SUBJECT: FINAL SAFETY EVALUATION REPORT FOR ANP-10268(P), REVISION 0,
"U.S. EVOLUTIONARY PRESSURIZED WATER REACTOR (EPR) SEVERE
ACCIDENT EVALUATION TOPICAL REPORT" (TAC NO. MD3830)

FINAL SAFETY EVALUATION BY THE OFFICE OF NEW REACTORS
ANP-10268(P), REVISION 0, "U.S. EVOLUTIONARY PRESSURIZED WATER REACTOR
(EPR) SEVERE ACCIDENT EVALUATION TOPICAL REPORT" (TAC NO. MD3830)
PROJECT NO. 733

Figure 2. Overview of U. S. EPR Severe Accident Analytical Methodology

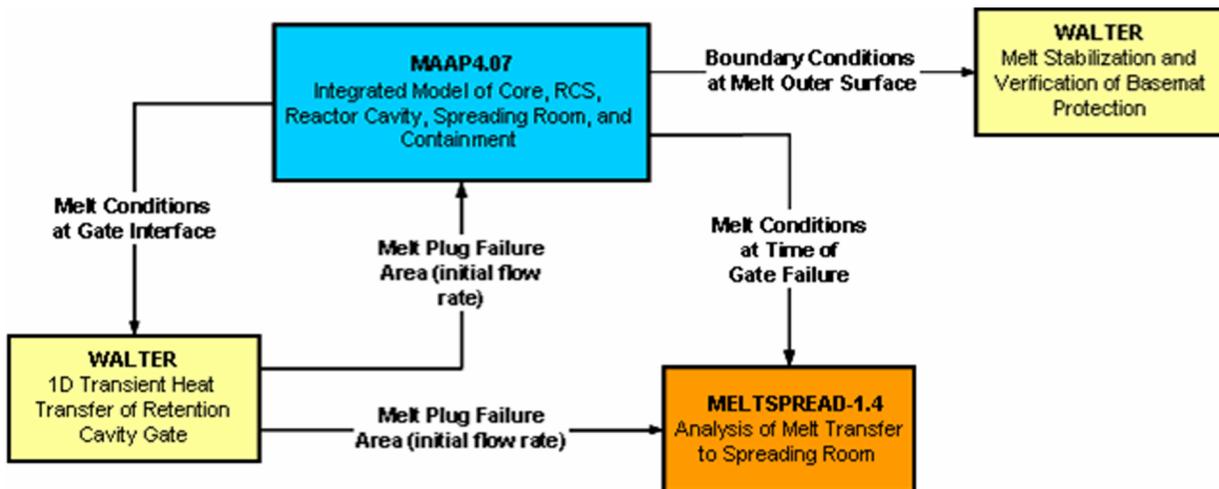
10. Page 21, Figure 2, "Overview of U.S. EPR Severe Accident Analytical Methodology," was updated with the replacement document pages submitted August 29, 2007 along with the 2nd set of RAI responses. Please use the updated figure.

The revised figure was identical to the original figure. The Figure remains unchanged.
